SERVICE BULLETIN

M-1151A

Safety Recall Code 0113

MAIN CIRCUIT BREAKER REPLACEMENT

Figure 1. Upper Frame Crossmember (Under Seat)

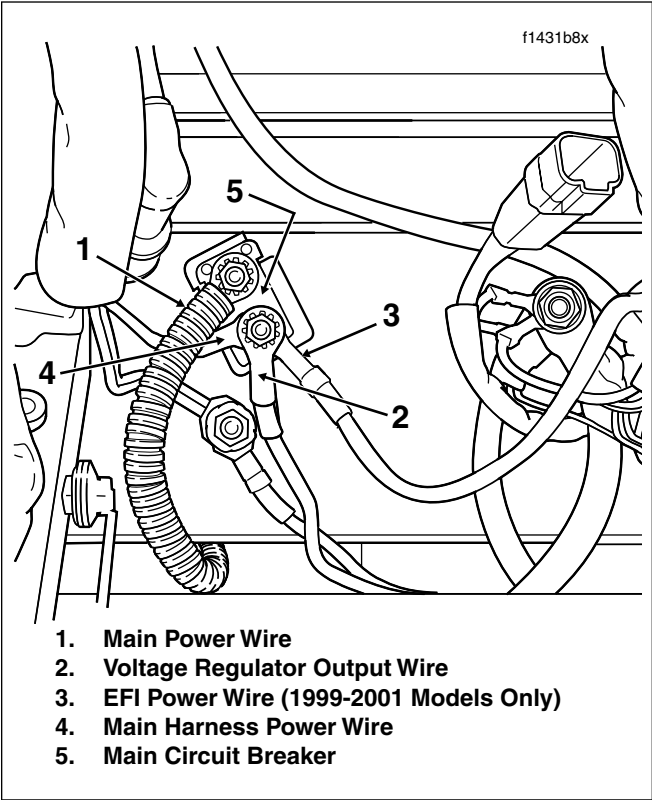
- 5. Locate main circuit breaker on left side of upper frame crossmember. See Figure 1.
- 6. Remove Keps nut from copper post. Remove main power wire ring terminal (with convoluted tubing).
- 7. Remove Keps nut(s) from silver post. Remove voltage regulator output, EFI power (1999-2001 models only) and main harness power wire ring terminals.
- 8. Bend tab on mounting clip outward and remove main circuit breaker.

- 1. Install **new** 50 amp main circuit breaker into mounting clip oriented with the copper post topside. See Figure 1.
- 2. Install main harness power, EFI power (1999-2001 models only) and voltage regulator output wire ring terminals onto silver post. Start Keps nut on post.

Install only upper Keps nuts on silver and copper posts. Discard lower Keps nuts wherever the previous configuration was double nutted.

- 3. Place main power wire ring terminal (with convoluted tubing) onto copper post and start Keps nut.
- 4. Alternately tighten Keps nuts to 20-35 **in-lbs** (2.3-4.0 Nm).
- 5. Place the battery into the battery box, terminal side forward.
